Access Compliance Report

Public Rights-of-Way

Intersection ID: 2743	Main Street: BELL'S_MILL_DR	Cross Street: HIGHLAND_CREEK_PY	Location: SW
ADA ID: 2D3F63670604	Ramp Type: Perp	Initial Pass/Fail: Fail	Overall Compliance: No
		Severity Score: 10

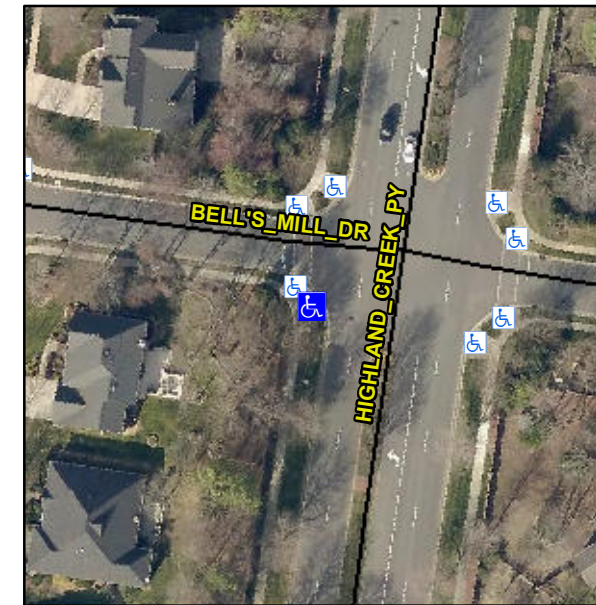
R304.5.1, R304.5.3

Compliance	Description	Data	Compliance	Description	Data
N/A	Ramp Length (in)	129.0	Yes	Ramp Slope (%)	6.3
No	Ramp Width (in)	43.0	No	Ramp XSlope (%)	4.7
N/A	Flare Type LT	N/A	N/A	Flare Type RT	N/A
N/A	Flare Slope LT (%)	N/A	N/A	Flare Slope RT (%)	N/A
N/A	Flare Traversable LT?	N/A	N/A	Flare Traversable RT?	N/A
N/A	Landing Length (in)	N/A	N/A	DWS Provided?	N/A
N/A	Landing Width (in)	N/A	N/A	DWS Contrast?	N/A
N/A	Landing Slope (%)	N/A	N/A	DWS Length (in)	N/A
N/A	Landing X Slope (%)	N/A	N/A	DWS Full Width?	N/A
N/A	Landing Curb? (Y/N)	N/A	N/A	DWS Offset (in)	N/A
N/A	Shared Landing?	N/A			
N/A	Gutter Ponding?	N/A	N/A	Gutter Slope (%)	N/A
N/A	Gutter Lip Ht (in)	N/A	N/A	Gutter X Slope (%)	N/A
N/A	Painted X Walk1?	No	N/A	Painted X Walk2?	N/A
	X Walk 1 Direction	To SE		X Walk 2 Direction	N/A
N/A	X Walk 1 Width (in)	N/A	N/A	X Walk 2 Width (in)	N/A
	X Walk 1 Slope (%)	6.1		X Walk 2 Slope (%)	N/A
	X Walk 1 X Slope (%)	1.8		X Walk 2 X Slope (%)	N/A

Remove & Replace Entire Ramp.
